Item Name: Crosstube Turning Detail

DART AEROSPACE LTD	Work Order:	99460
Description: Crosstube Assembly	Part Number:	D206-667-243
Inspection Dwg: D206-667-243 Rev: C		Page 1 of 2

DRAWING NO. D206-667-243	TITLE CROSSTUBE ASS'Y (206L HIGH AFT)	REV. C	DART AEROSPACE LTD ENGINEERING ORDER		D.E.O. NO. D206-667-243-C-1	SHEET NO. SHEET 1 OF 1	SCALE NTS
DRAWN 97	CHECKED ASS	MFG. APPR. RB	APPROVED MP	DE APPR. #			
DATE 11.07.15	DATE 11.07.20	DATE 11.07.21	DATE 11/07/21	DATE 11.07.21

PURPOSE:

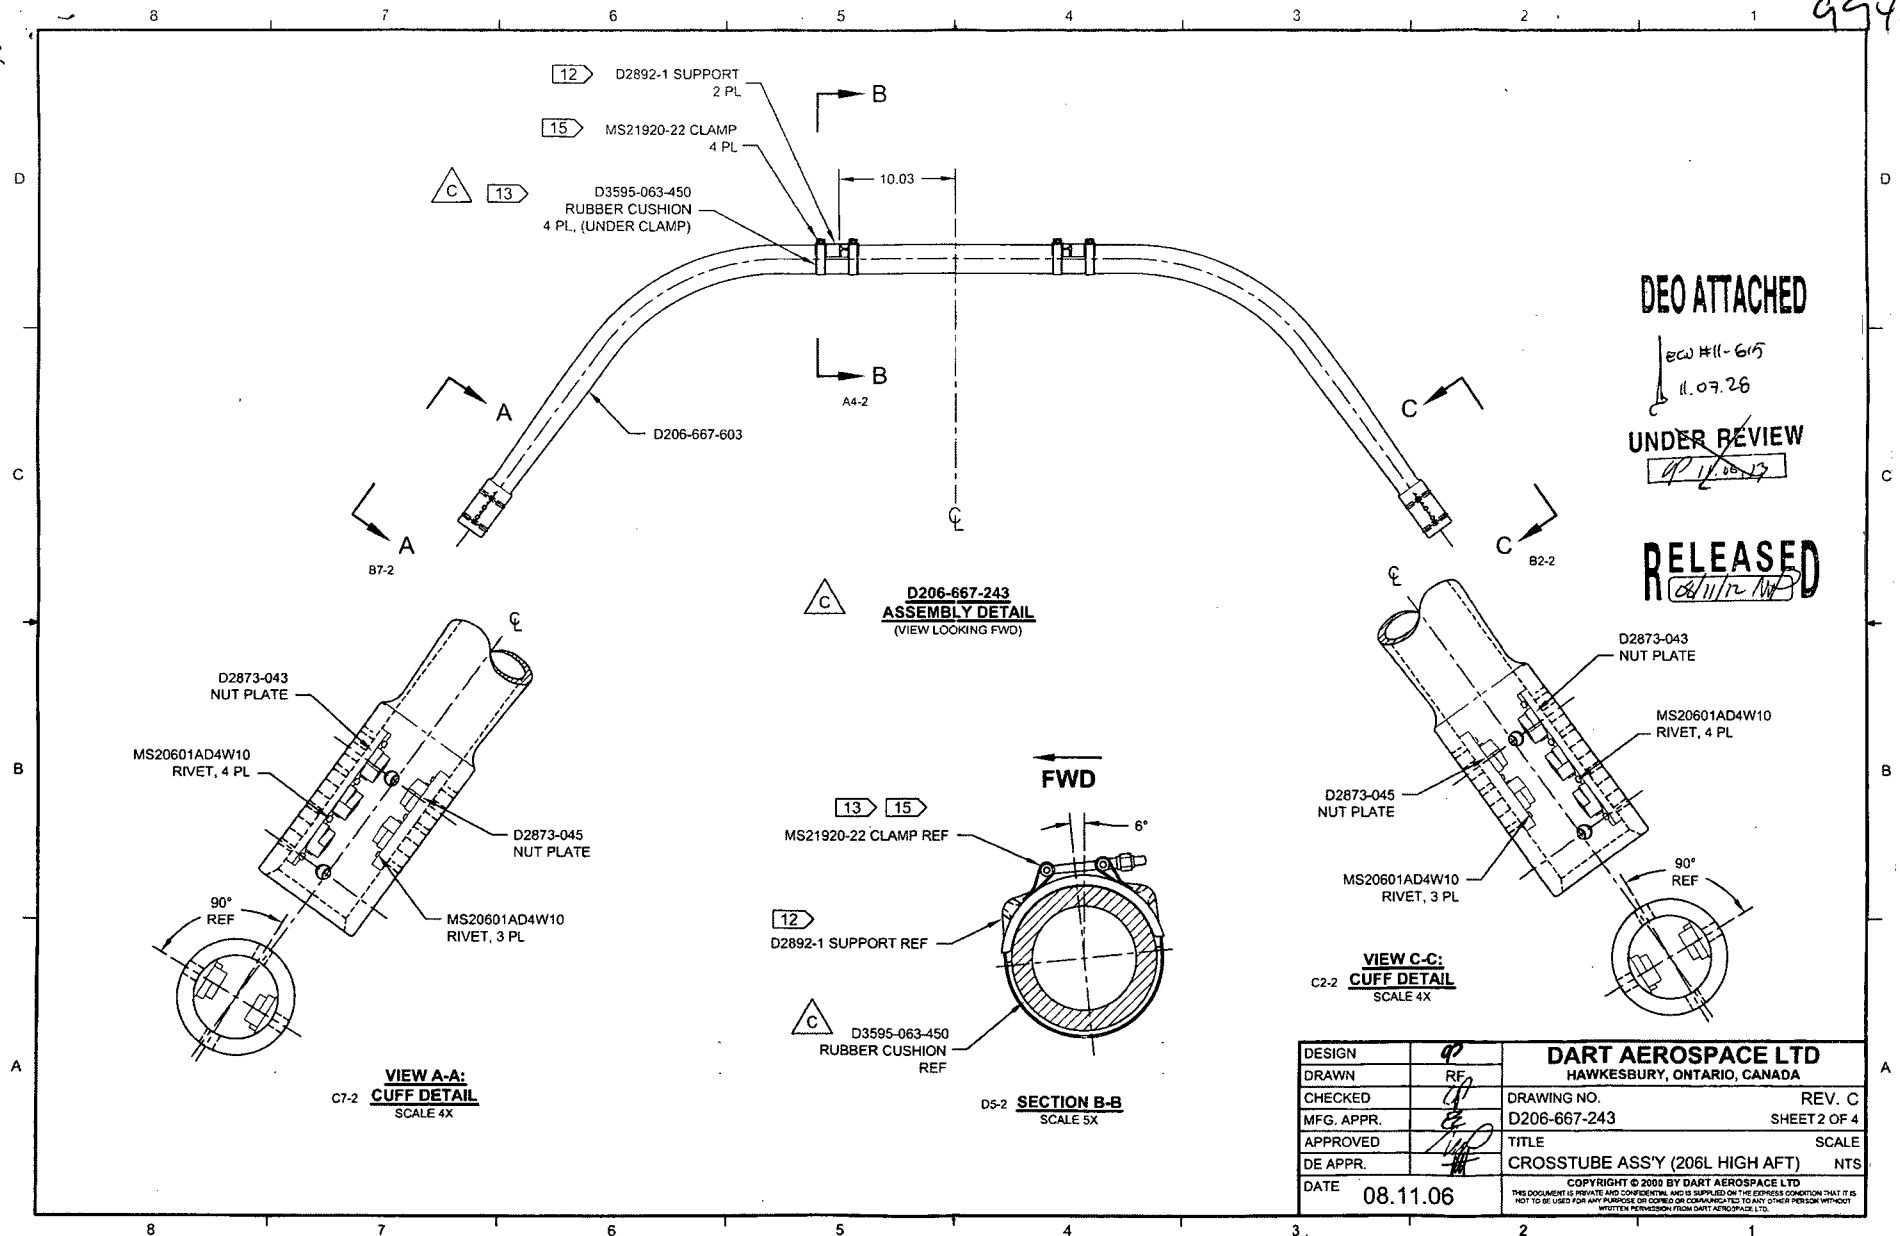
REPLACE MAGNOBOND WITH PROSEAL.

IS:

Item	Qty -243	Part Number	Description
9	A/R	PROSEAL 890 B-2	SEALANT, AMS-S-8802 CLASS B-2

WAS:

9	A/R	MAGNOBOND 6398	ROCKWELL SPECIFICATION RBO-120-023 ADHESIVE (TEXTRON/BELL SPEC. 299-947-100, TYPE II, CLASS 2 ADHESIVE)
---	-----	----------------	---

NOTE 12 & 15, SHEET 1 IS AMENDED AS FOLLOWS:

IS:

- 12) TO INSTALL D2892-1 SUPPORT: ABRABE MATING SURFACE OF SUPPORT AND CROSSTUBE WITH 180-GRIT SANDPAPER AND REMOVE RESIDUE WITH MEK (OR EQUIVALENT). APPLY A 0.04" TO 0.07" THICK LAYER OF PROSEAL 890 CLASS B-2 (OR AMS-S-8802 CLASS B-2) SEALANT TO MATING SURFACE OF SUPPORT.
- 15) TORQUE CLAMPS 80 TO 100 IN-LB. ENSURE AT LEAST 1.5 THREADS SHOWING IN SAFETY AND THAT NUT HAS NOT BOTTOMED-OUT AFTER TORQUING. **PRIOR TO PACKAGING, RE-CHECK TORQUE ON CLAMPS AFTER PROSEAL 890 SEALANT HAS CURED FOR 72 HOURS.**

WAS:

- 12) INSTALL D2892-1 SUPPORT USING 0.03" TO 0.06" THICK LAYER OF MAGNOBOND 6398 PER QSI 015. LET CURE FOR 12 HOURS AFTER INSTALLATION AND PRIOR TO PACKAGING.
- 15) TORQUE CLAMPS 80 TO 100 IN-LB. ENSURE AT LEAST 1.5 THREADS SHOWING IN SAFETY AND THAT NUT HAS NOT BOTTOMED-OUT AFTER TORQUING.
